## De Tomaso of America

THE FOLLOWING MODIFICATIONS HAVE PROVEN TO HELP SOME OF THE GROWING PAINS FROM WHICH THE PANTERA SUFFERS.

R.H. KICK PANEL

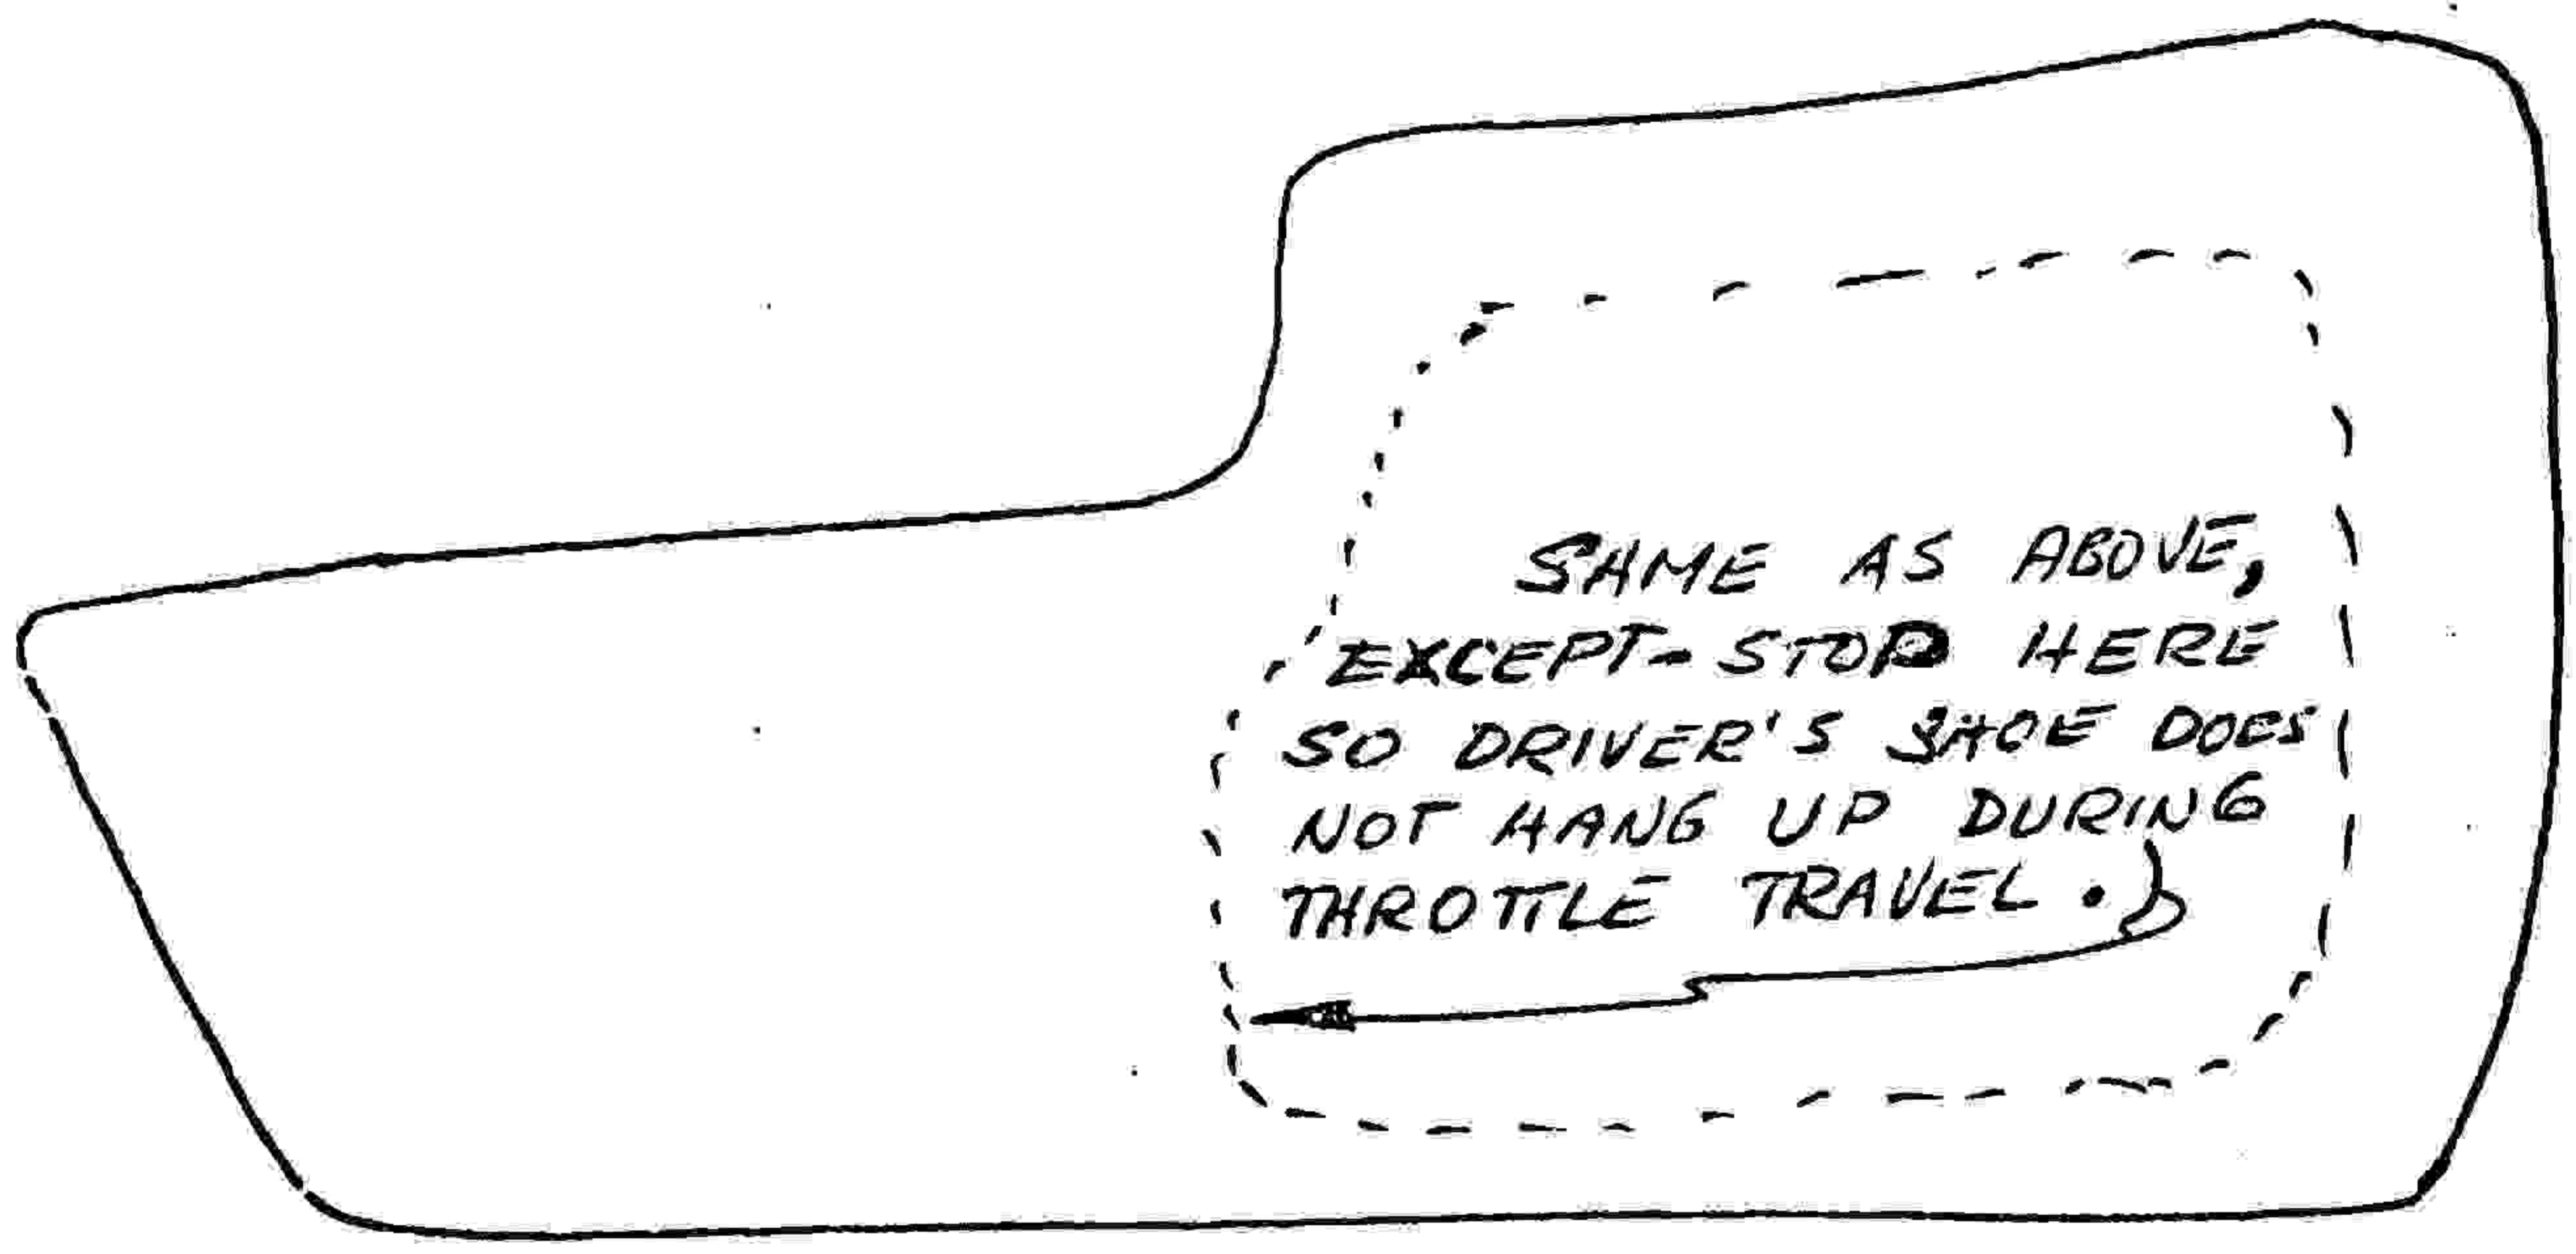
① BOTTOM VENT DOOR IS 90% ENCLOSED WITHIN CONSOLE KICK PANELS AND RESTRICTED TO 50% OF BEING FULLY OPEN BECAUSE OF CONTACT WITH TOP EDGE OF R/H KICK PANEL. THEREFORE THE TWO UPPER DASH VENT DOORS ALSO DO NOT OPEN FULLY AS UPPER & LOWER VENT DOORS OPERATE FROM A COMMON BELL CRANK.

REMOVE BOTH KICK PANELS AND  
MODIFY AS PER DIAGRAM.

MODIFYING THESE PANELS INCREASES AIR CIRCULATION BY NO LESS THAN 50%.

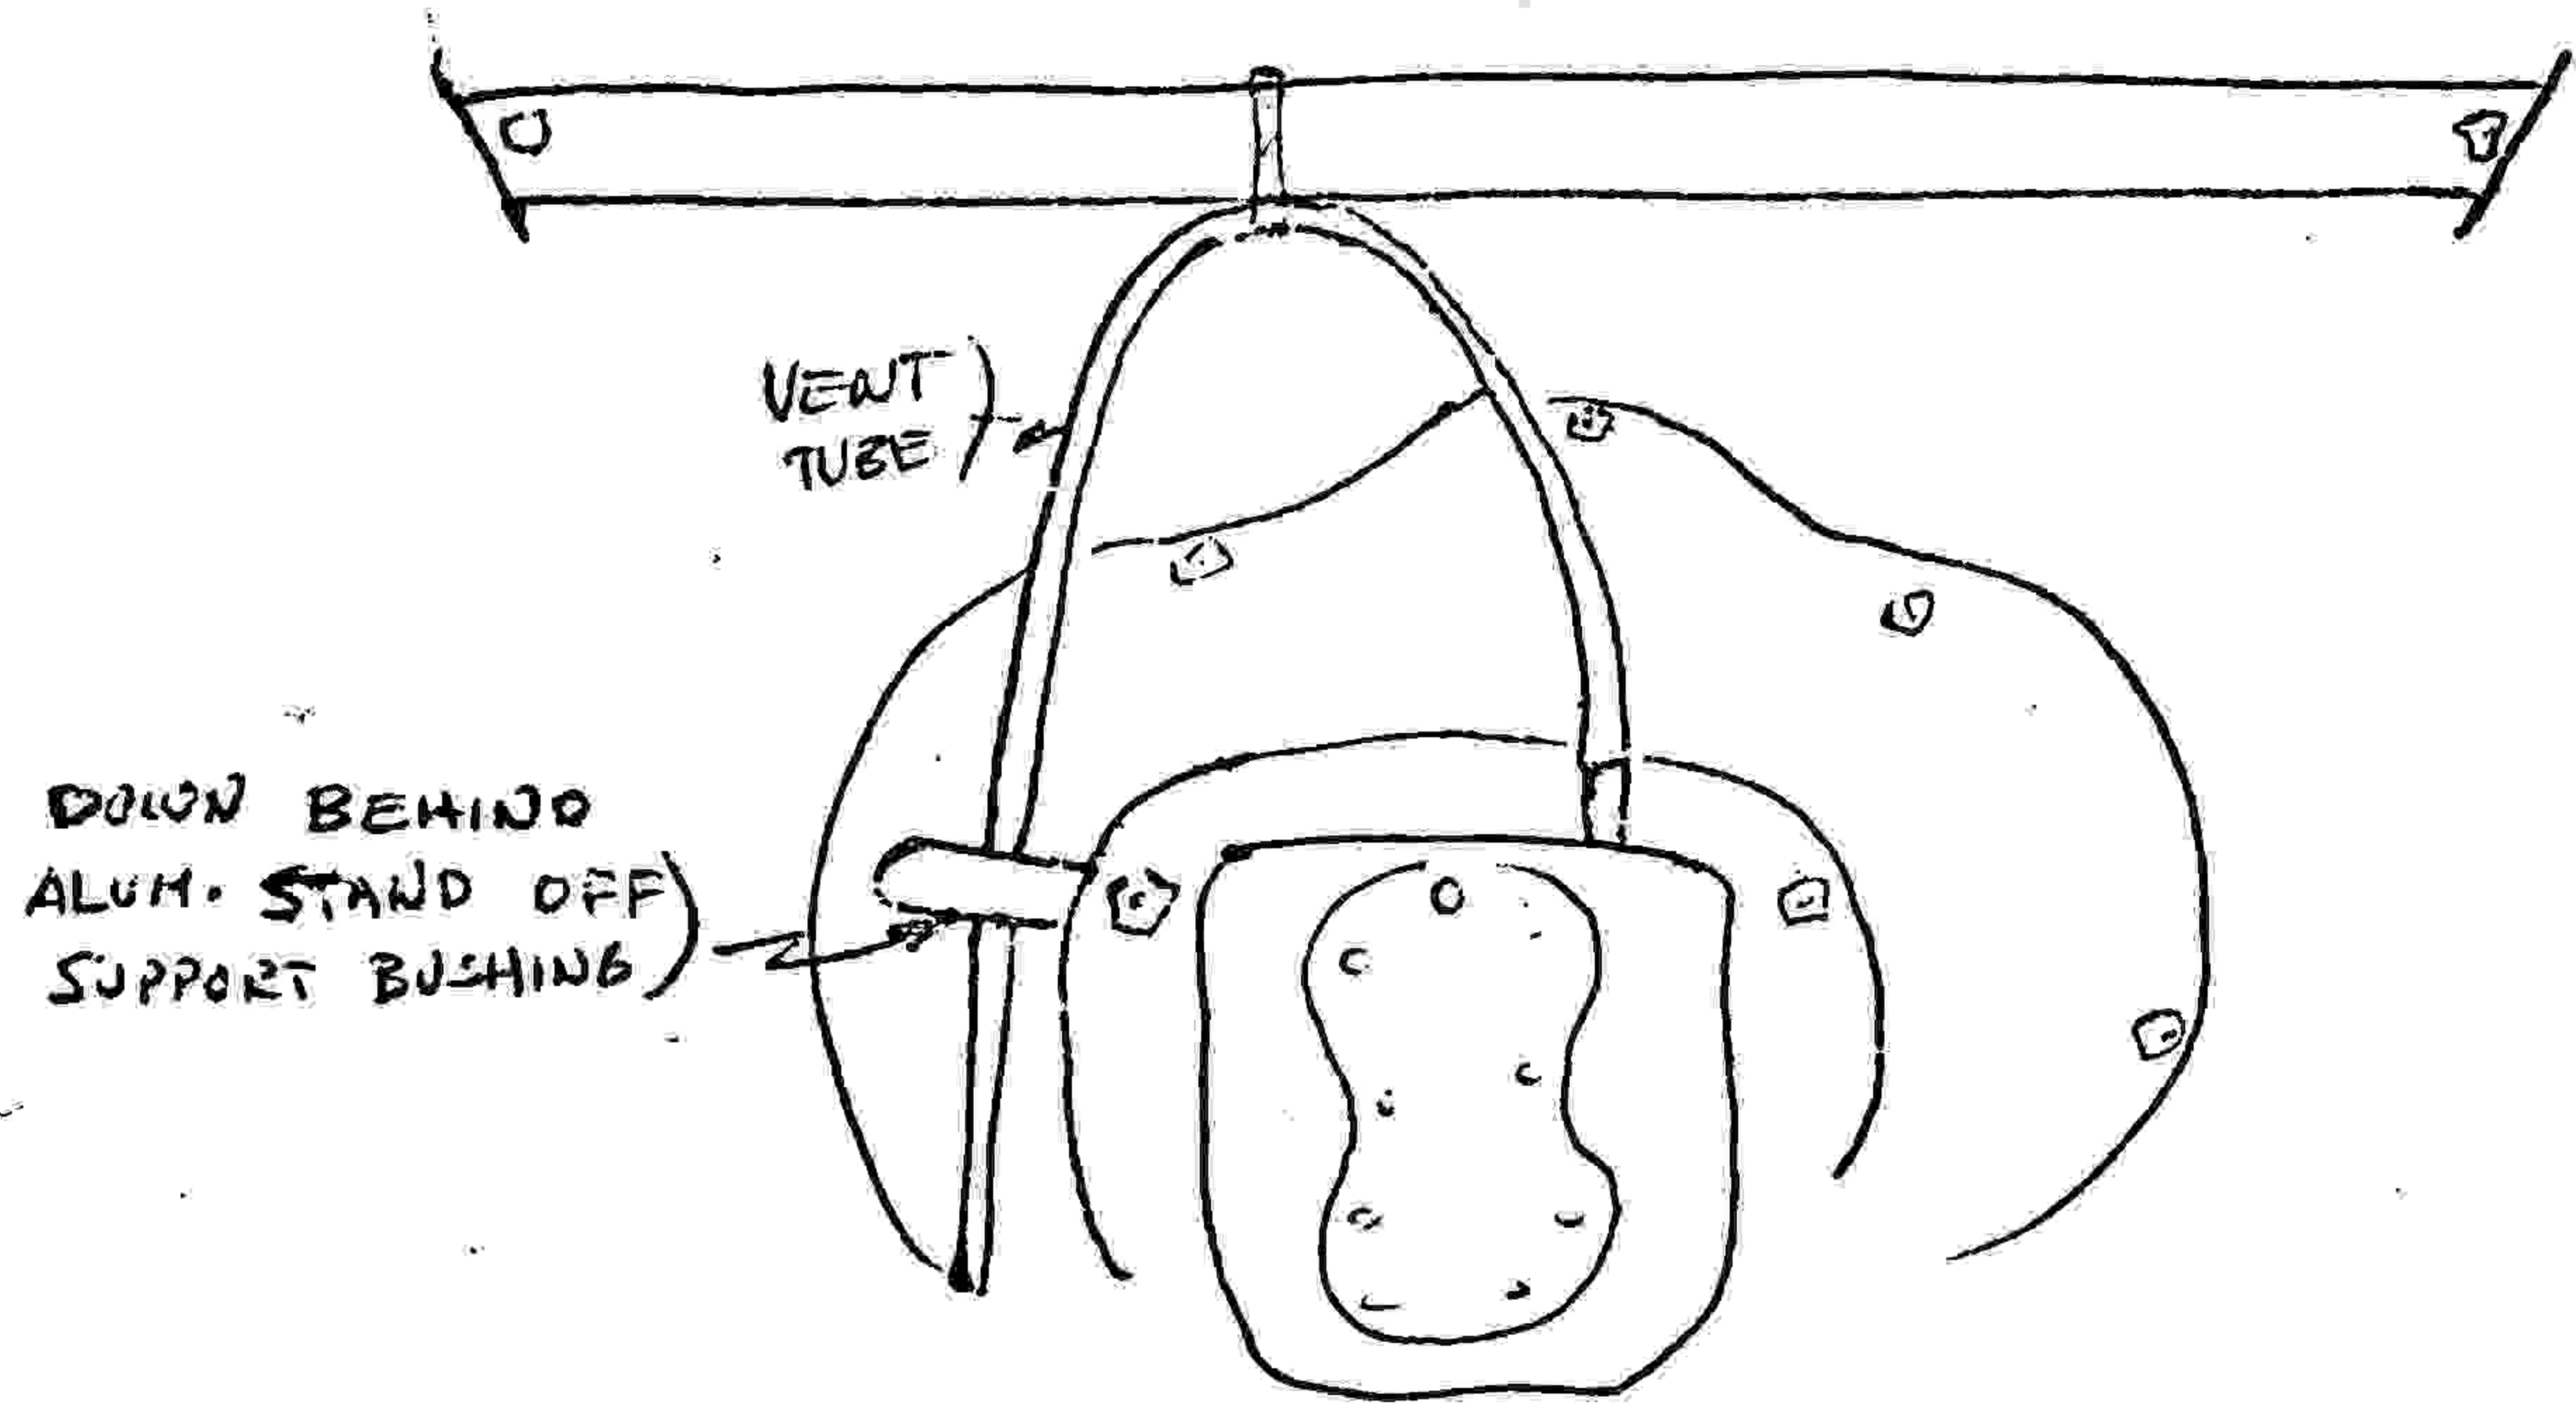
FREON CHARGE HAS BEEN FOUND VERY LOW IN APPROX. 75% OF ALL PANTERAS. THIS WAS OVERLOOKED IN PRE-DELIVERY, APPARANTLY ON THE ASSUMPTION FACTORY NEW CARS WOULD NATURALLY BE FULLY CHARGED. THERE AIN'T NO WAY, BROTHER.

CHECK AT SIGHT GLASS IN DRIER TANK LOCATED AT RIGHT REAR. OF CAR, UNDER REAR ENGINE COVER
